# OTWAY WATER BOOK 56

## **“Barwon Water’s Last and Final Gerangamete Groundwater Borefield Extraction Report, 2018-2019.”**

### **The 2018-2019 Gerangamete Borefield Report.**

**6. Water Level Limits if Exceeded Require Additional Action.**

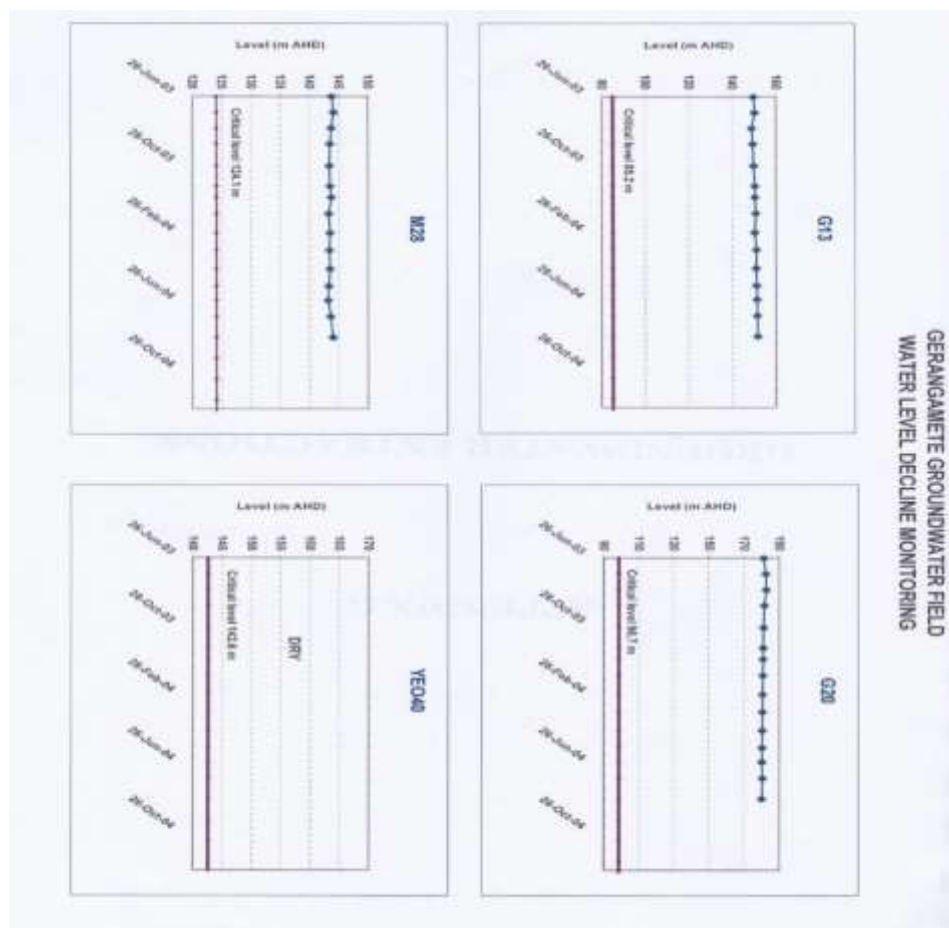
Part 6 of the 2018-2019 report discusses groundwater levels in 4 important bores as per licence condition 3.5a(i) (see Appendix Twelve, page 60).

Leading up to the finalising of the licence in 2004, it had been determined during the discussions, preparation, a report by Barnett<sup>(26)</sup> and writing up of the conditions, that if the water levels in Yeo 40 fell below the 158 m level, Boundary Creek would no longer receive discharge from a full and overflowing aquifer. The creek would dry up and the adjoining wetlands would follow suit. To stop this happening an extra tolerance safety margin or buffer of 0.5 of a metre, was added to this level so that action could be taken before it fell below the 158 m mark. Unfortunately, the Yeo 40 water level has been below this very important marker for decades. Recognition of the importance of this fifth water level marker has taken a very lowly “back seat,” barely being acknowledged or highlighted.

Figure 3: Flows and releases to Boundary Creek at Yeodene for 2017/18 and 2018/19

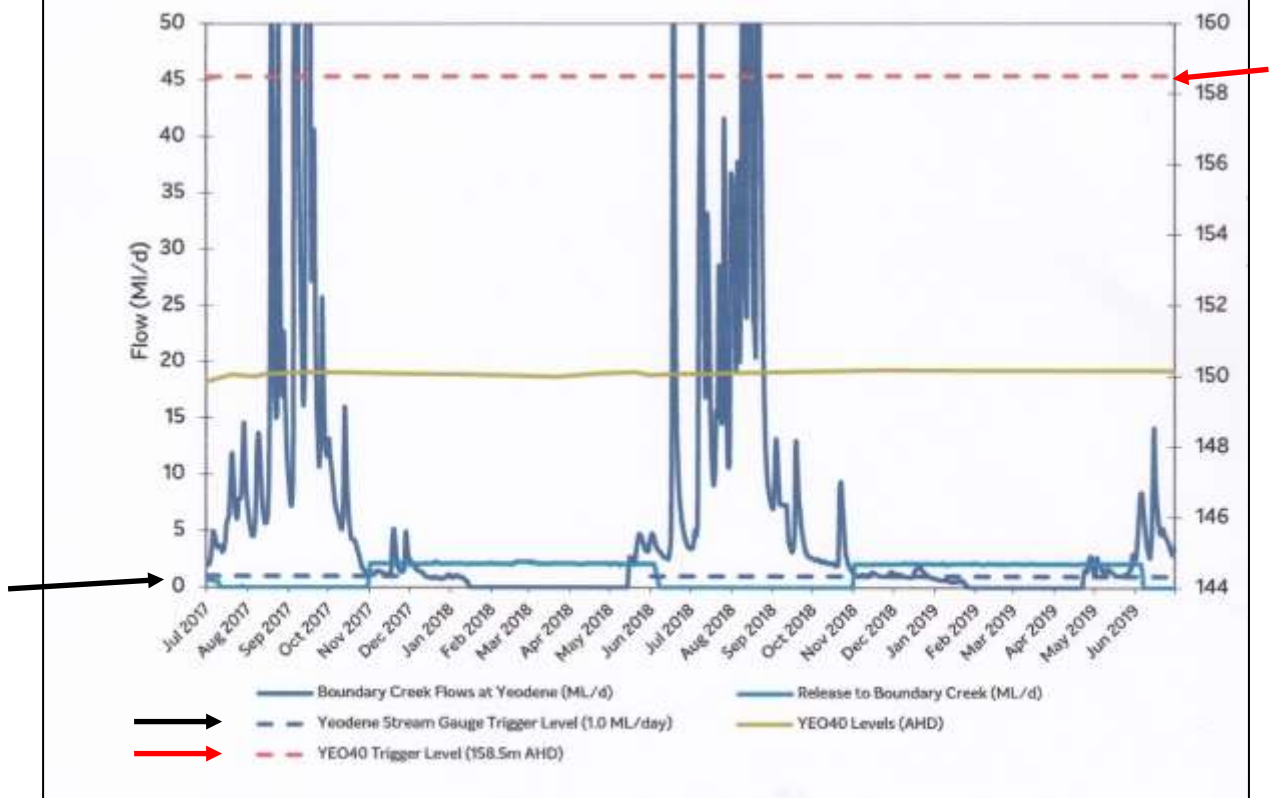
The water levels referred to in Clause 3 have been called “**Critical levels**” whereas the “critical” water levels in Clause 6 have been called “**Trigger levels**”. As mentioned earlier the word “critical” has been adopted as a means of convenience just as the word “trigger” has. No where in licence BEE0032496 does it mention trigger levels.
